Access Compliance Report

Public Rights-of-Way

(Curb Ramps)

Intersection ID: 22519	Main Street: SHARON_RD	Cross Street: AYRSHIRE_PL	Location: W
ADA ID: 94FEF5439B7A	Ramp Type: PerpDiag	Initial Pass/Fail: Fail	Overall Compliance: No
Severity Score: 21.25			
Codes/Mitigation Info/Possible Solution		Field Measurements/Component Compliance

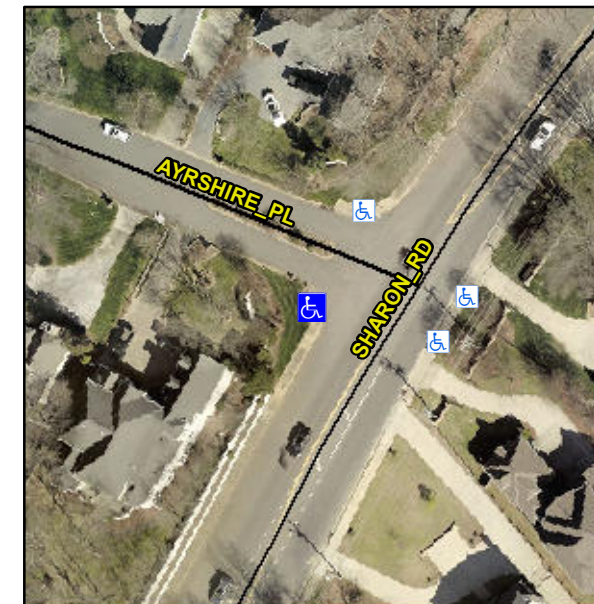
Not Found, R304.5.1, R304.2.2

Compliance	Description	Data	Compliance	Description	Data
N/A	Ramp Length (in)	59.5	No	Ramp Slope (%)	10.4
No	Ramp Width (in)	38.0	Yes	Ramp XSlope (%)	1.8
N/A	Flare Type LT	N/A	N/A	Flare Type RT	N/A
N/A	Flare Slope LT (%)	N/A	N/A	Flare Slope RT (%)	N/A
N/A	Flare Traversable LT?	N/A	N/A	Flare Traversable RT?	N/A
N/A	Landing Length (in)	N/A	N/A	DWS Provided?	N/A
N/A	Landing Width (in)	N/A	N/A	DWS Contrast?	N/A
N/A	Landing Slope (%)	N/A	N/A	DWS Length (in)	N/A
N/A	Landing X Slope (%)	N/A	N/A	DWS Full Width?	N/A
N/A	Landing Curb? (Y/N)	N/A	N/A	DWS Offset (in)	N/A
N/A	Shared Landing?	N/A			
N/A	Gutter Ponding?	N/A	N/A	Gutter Slope (%)	N/A
N/A	Gutter Lip Ht (in)	N/A	N/A	Gutter X Slope (%)	N/A
N/A	Painted X Walk1?	No	N/A	Painted X Walk2?	No
	X Walk 1 Direction	To SE		X Walk 2 Direction	To NE
N/A	X Walk 1 Width (in)	N/A	N/A	X Walk 2 Width (in)	N/A
	X Walk 1 Slope (%)	1.0		X Walk 2 Slope (%)	0.2
	X Walk 1 X Slope (%)	0.2		X Walk 2 X Slope (%)	1.9

Remove & Replace Curb Ramp With Two New Directional Ramps or Equivalent.
